# UNITED STATES PATENT AND TRADEMARK OFFICE

10/601,040

<b>Office Action Summary</b>	<b>Application No.</b>	<b>Applicant(s)</b>	
	10/601,040	GREGOIRE, WAYNE JACOB	
	<b>Examiner</b>	<b>Art Unit</b>	
	Shelley Self	3725

## **DETAILED ACTION**

FIG. 1

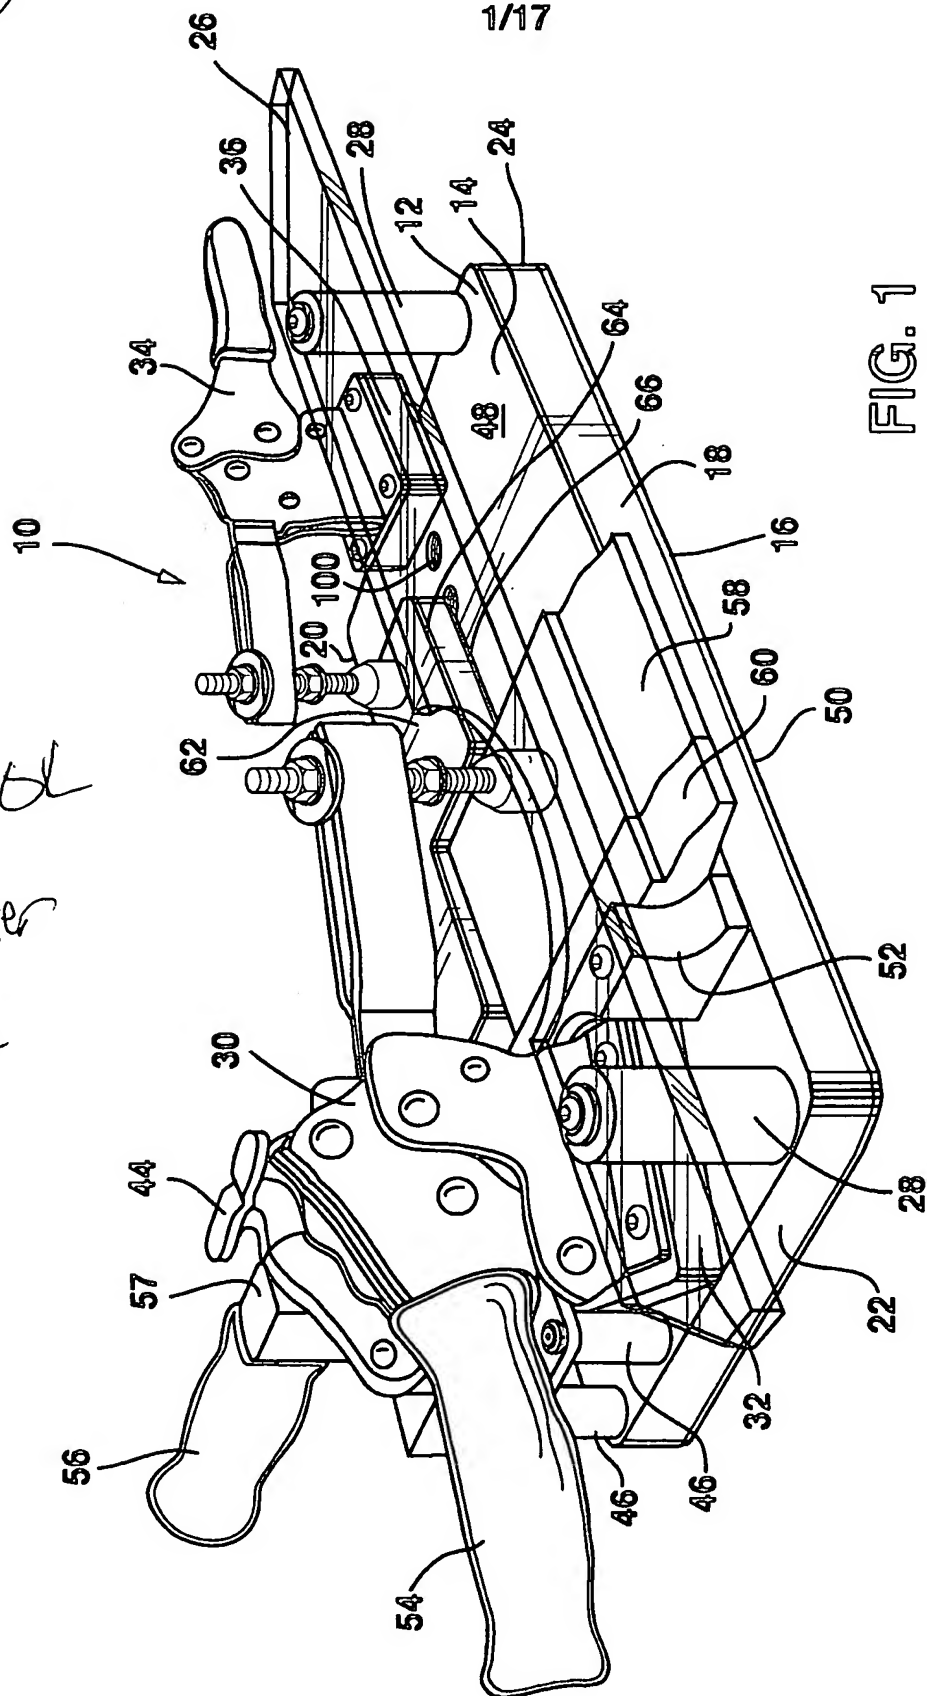
Approved &  
to Enter  
Sheet
